# **Venuti Enterprises, Inc. Excavation**

## **Route 82**

**Montville, Connecticut**

## **Environmental Review Team Report**

Figure 6  
Proposed Alterations to Clearing Limit Line Wetland #11

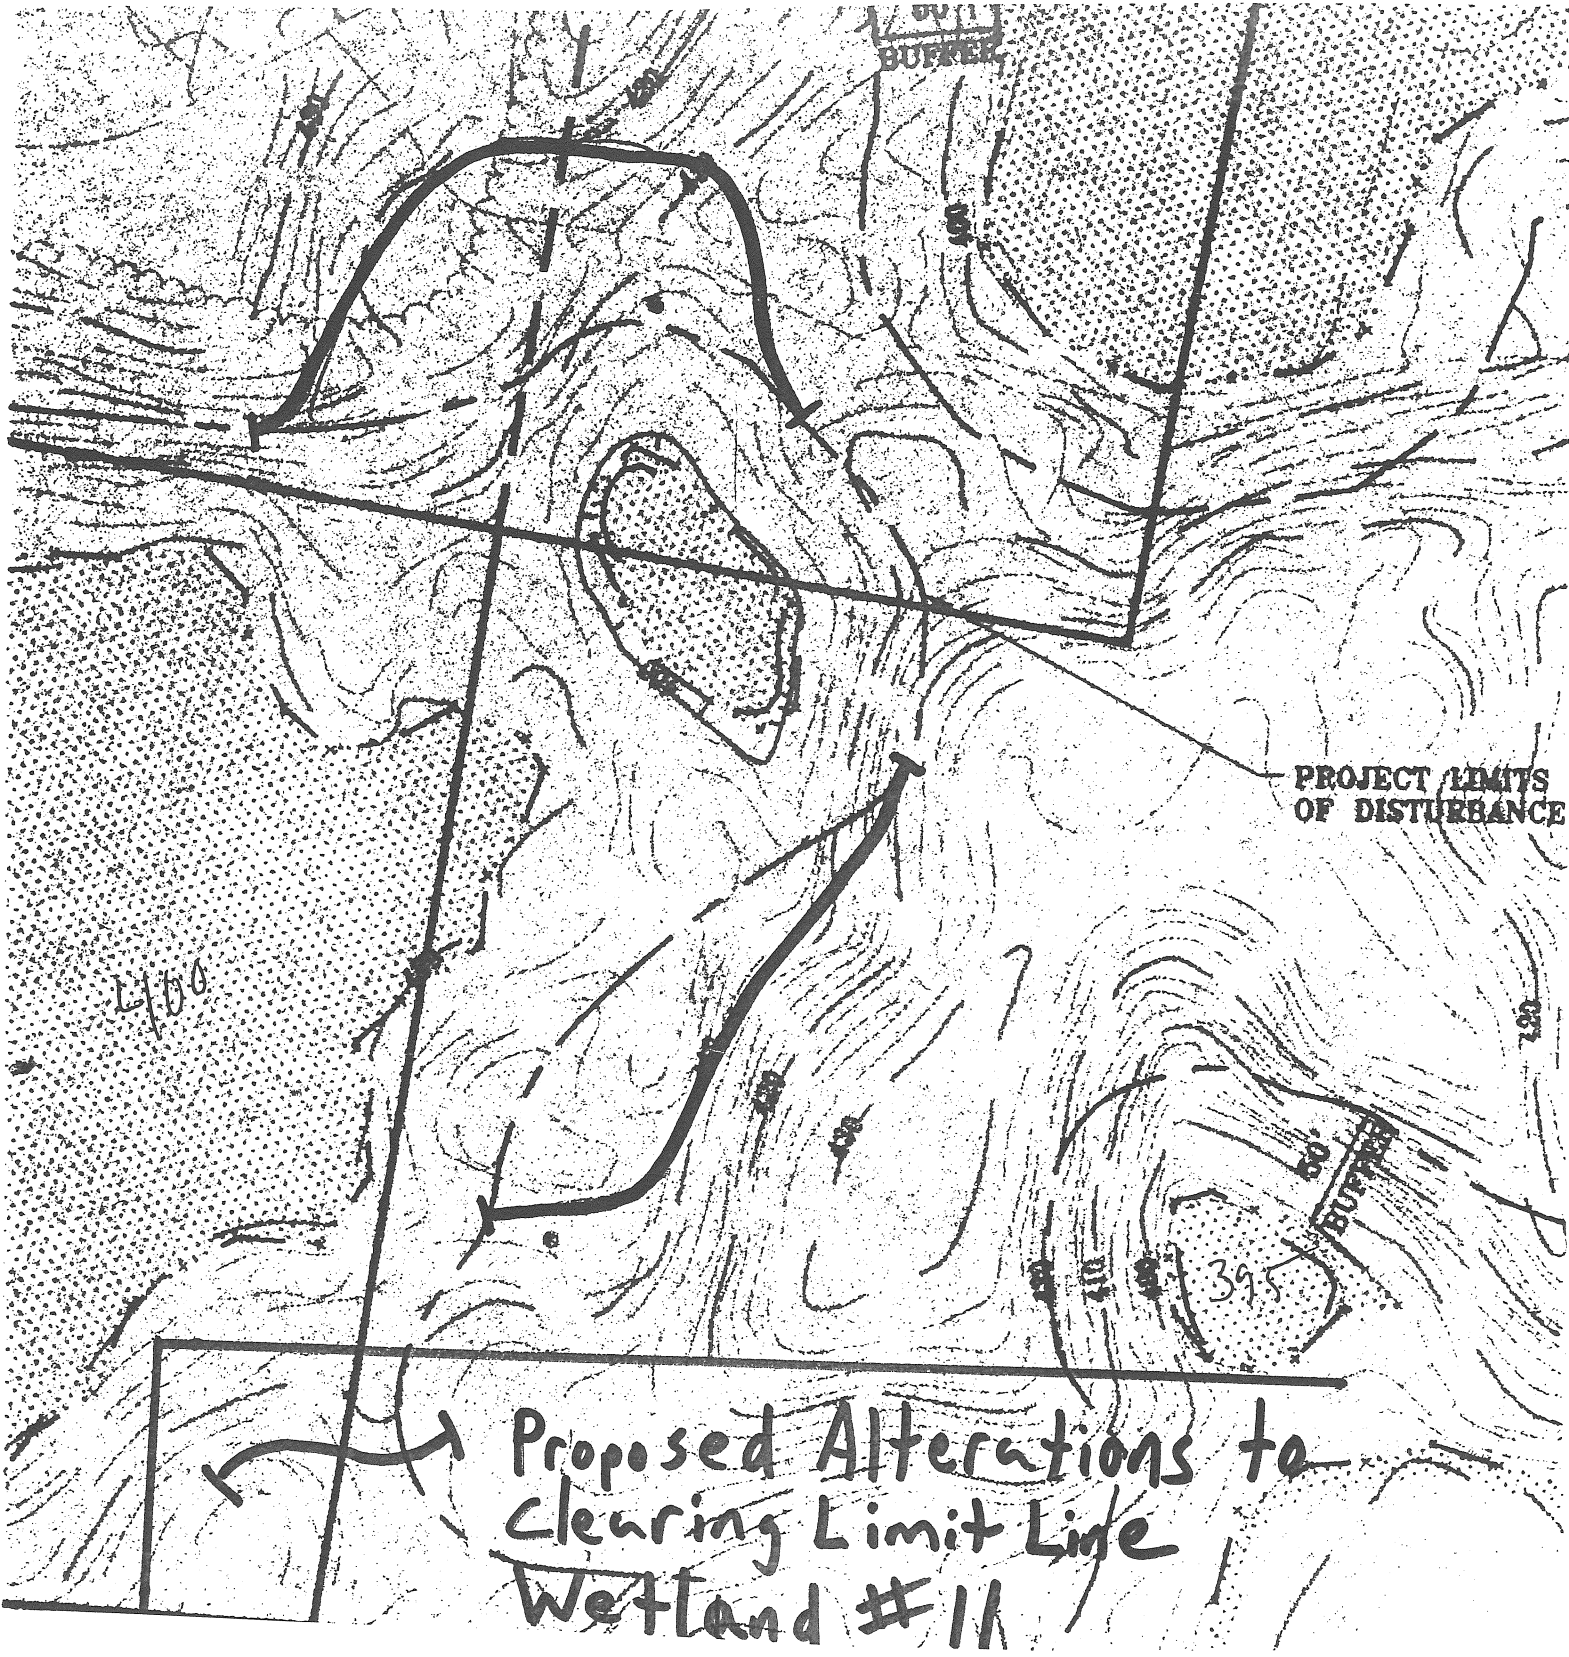
preserving these notable wetland areas. Formulating a protection plan based on predicted migration routes is very useful, but at the same time difficult to establish, due to the amount of field research necessary to accomplish this. One way of predicting these routes is to rule out certain topographic barriers such as steep banks or channels. Fortunately, most of the areas between the vernal pools and the excavation areas consist of steep banks leading toward the excavation area with most of the flatter, easily traversed routes leading toward the undeveloped portions of the site. However, one buffer area which could be expanded is that of wetland #11. Refer to Figure 6 for a diagram indicating a proposed alternative. These changes would greatly expand the area available for upland migration while at the same time preserve the access road for Phase IV of the project.

Figure 7

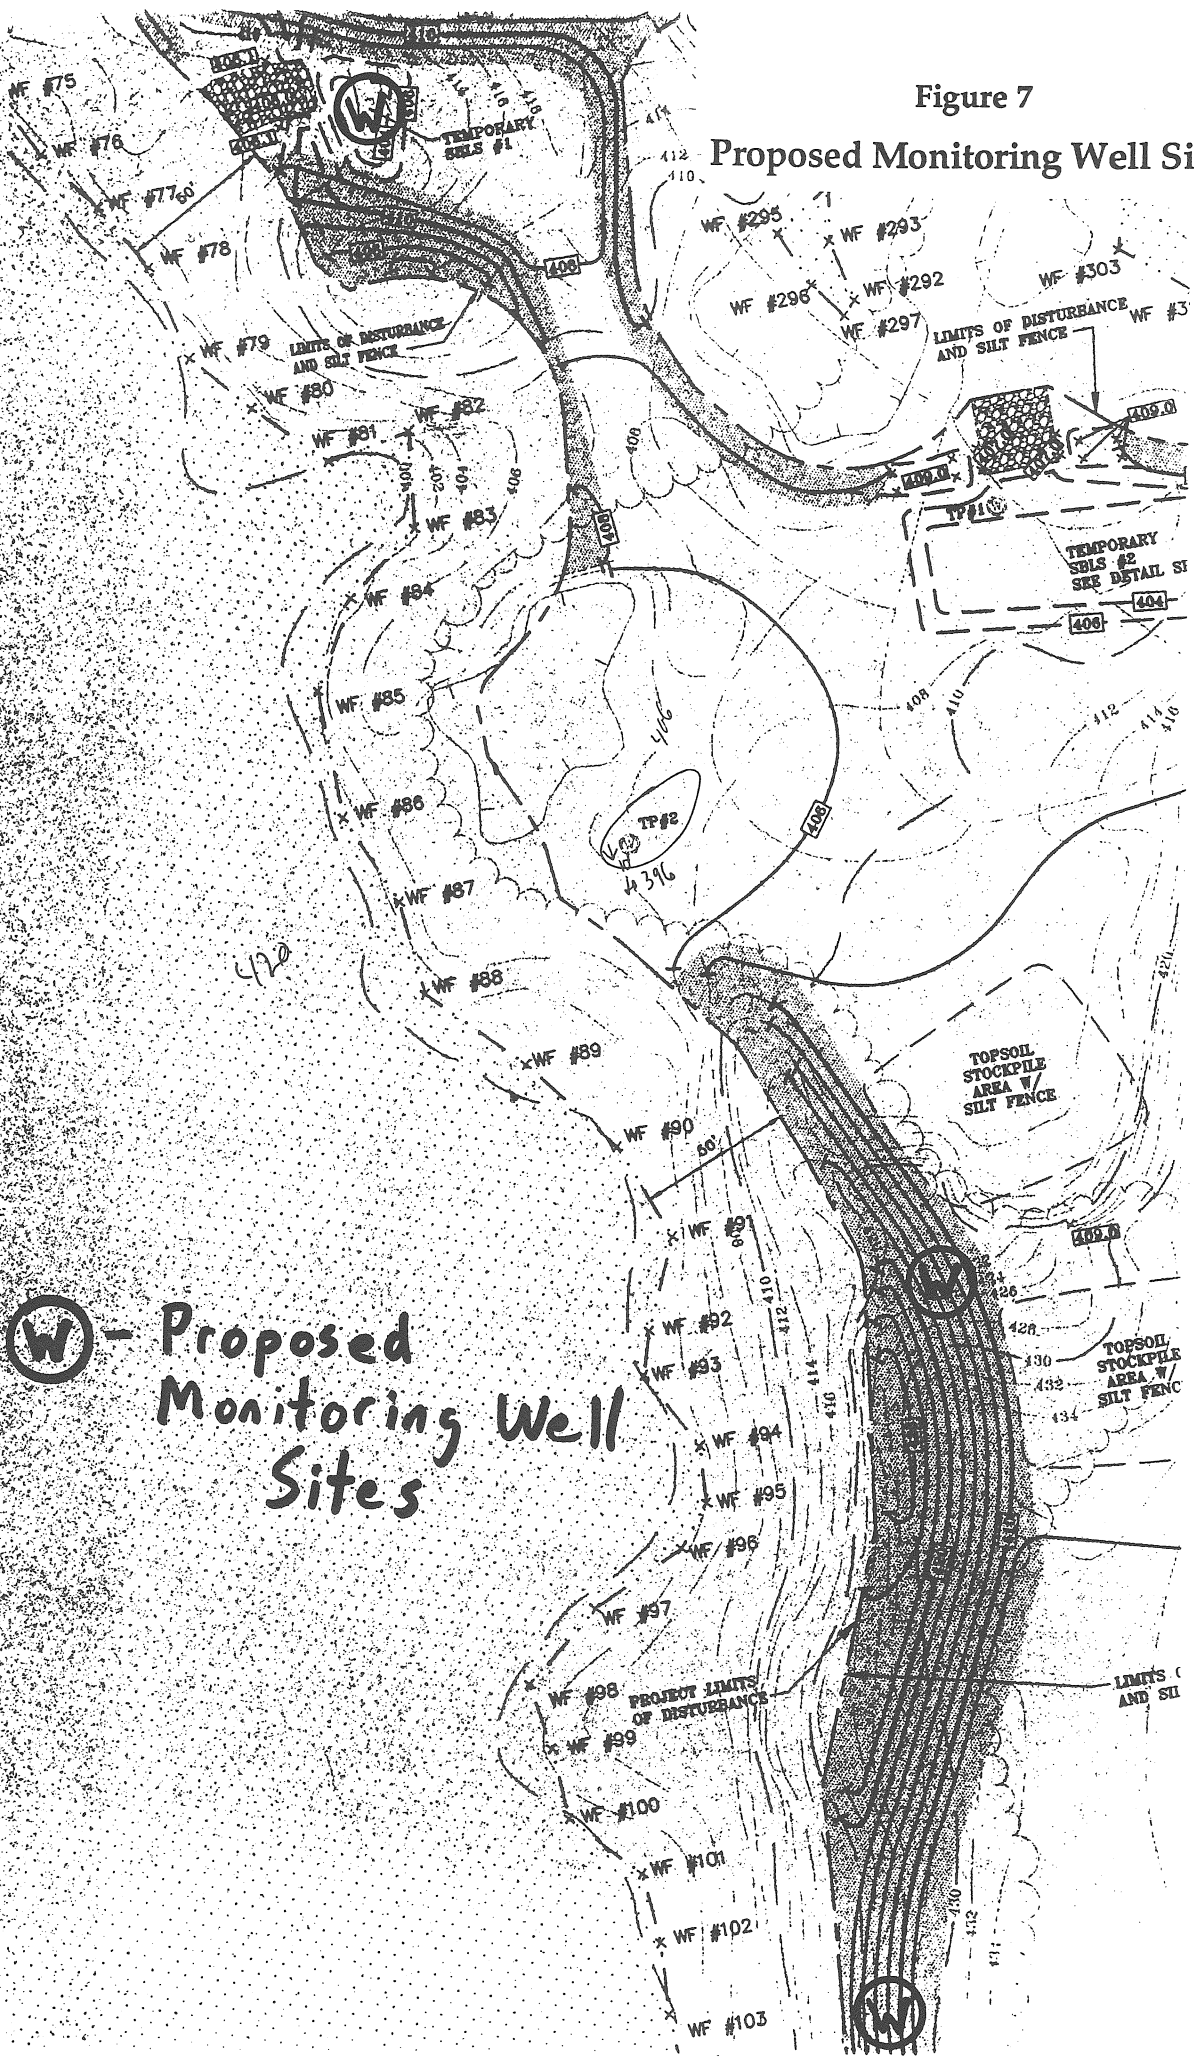
However, the fact that no groundwater table was detected 75 feet from this wetland (elevation 420') at Test Pit #2 (sample elevation of 400') reaffirms the fact that this wetland reflects a very high hydraulic gradient of a “perched” watertable wetland. Therefore, the planned excavation here will most likely not intercept any groundwater. For further assurance it may be beneficial to install a groundwater monitoring well at the locations indicated on Figure 7 to determine if conditions are similar as in the area of Test Pit #2.
